### Title *Design Hierarchy*

Title  
**Power Stage**

## Title Microcontrollers Stage

### Shock Stage

### Switching Power Supply

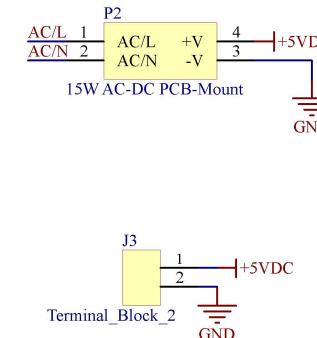
**Design Error**  
There is a mismatch between the power supply footprint and the mechanical model.

## Shock Current Calibration

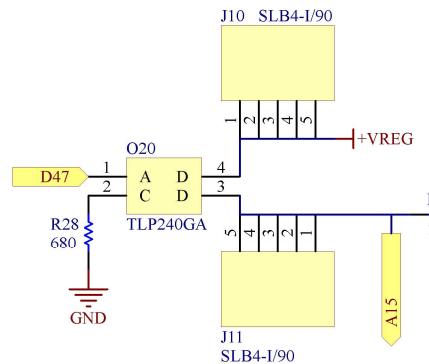
### Design Error

If the optocoupler is activated, a short-circuit occurs between the two safety plug sockets. This optocoupler is ignored and the calibration procedure is performed by controlling the AC power relay and the capacitor discharge. Furthermore, in the footprint of the plug socket it should only be connected to the center pin. The other pins are to provide stabilization when mounted on the PCB.
